Docket Number:	97-AFC-02C
Project Title:	Sutter Power Plant Application for Certification
TN #:	200901
Document Title:	SEC Air Permit Modification Letter to Feather River AQMD
Description:	N/A
Filer:	Sarah Madams
Organization:	CH2M HILL
Submitter Role:	Applicant Consultant
Submission Date:	10/16/2013 10:51:00 AM
Docketed Date:	10/16/2013

Subject: Sutter Energy Center (97-AFC-2C), Air Permit Modification Letter to Feather River AQMD

Subject: Permit Modification for the Sutter Energy Center (Title V Permit No. P13005)

Figure 1

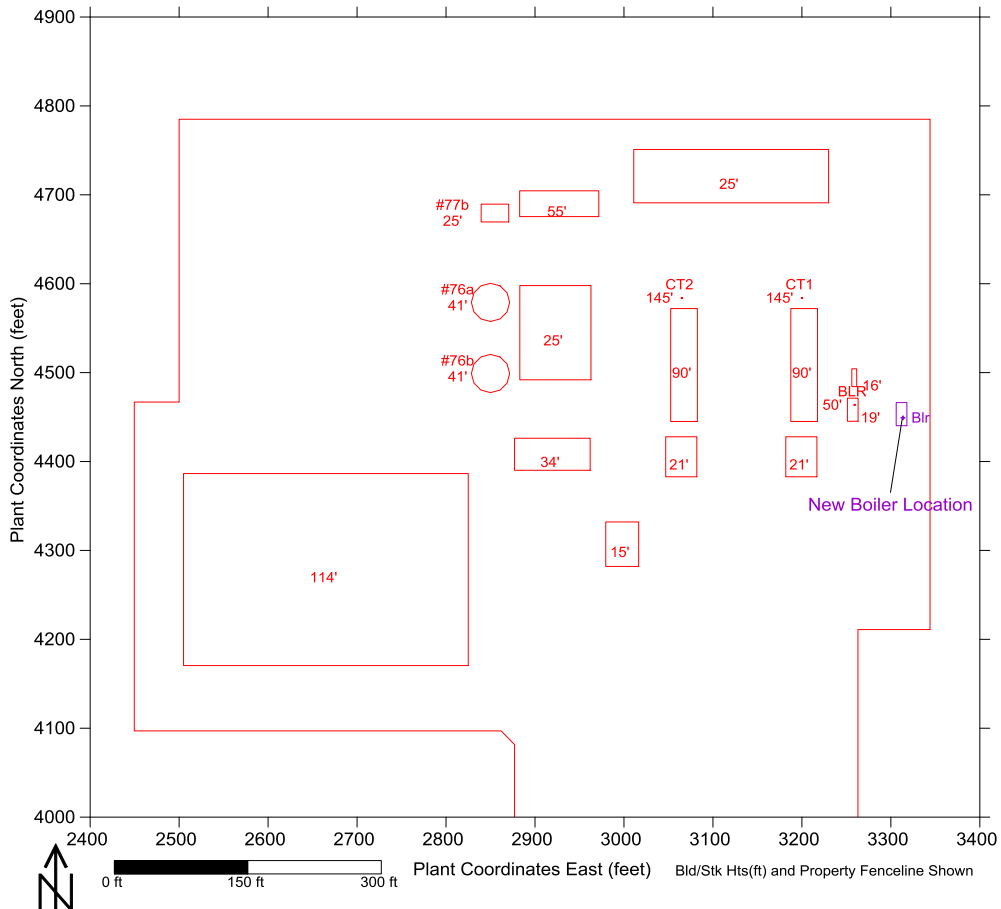
Since the amendment was submitted, the placement of the auxiliary boiler on-site has been revised to reflect a location approximately 52 feet due east of the location modeled in the previous permit amendment. Figure 1 displays the revised location of the auxiliary boiler in relation to the existing equipment at SEC and in relation to the previous placement of the auxiliary boiler.
